DOCKET ITEM #17

**Development Special Use Permit #2007-0027**

**4880 Mark Center Drive–Institute for Defense Analysis(IDA)**

<b>Staff Recommendation: APPROVAL WITH CONDITIONS</b>
<b>Staff Reviewers: Dirk H. Geratz, AICP</b> Colleen Rafferty

Graphic #1.

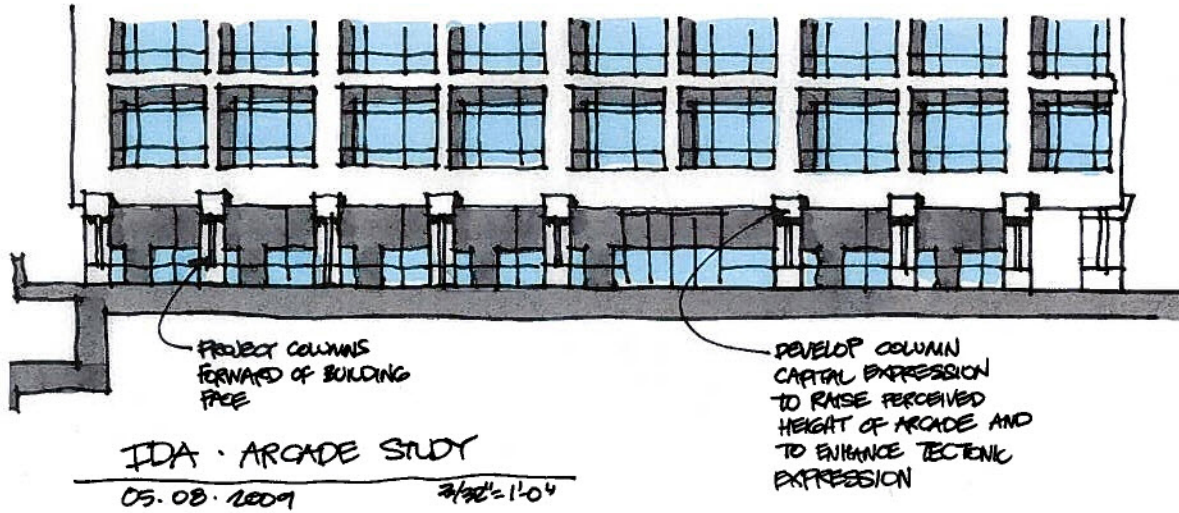
22. Provide the following building refinements to the satisfaction of the Director of P&Z:
- a. Continue to work with staff to explore revising the first floor arcade design of both the Phase I and Phase II buildings to increase the perception of height and tectonic strength. A suggestion is to move the currently recessed columns outboard of the respective building facades, which would also allow the height of these columns to be extended into the fascia of the façade above, enhancing the expression of structural support, and adding additional detail and shadow lines, as depicted in graphic # 1
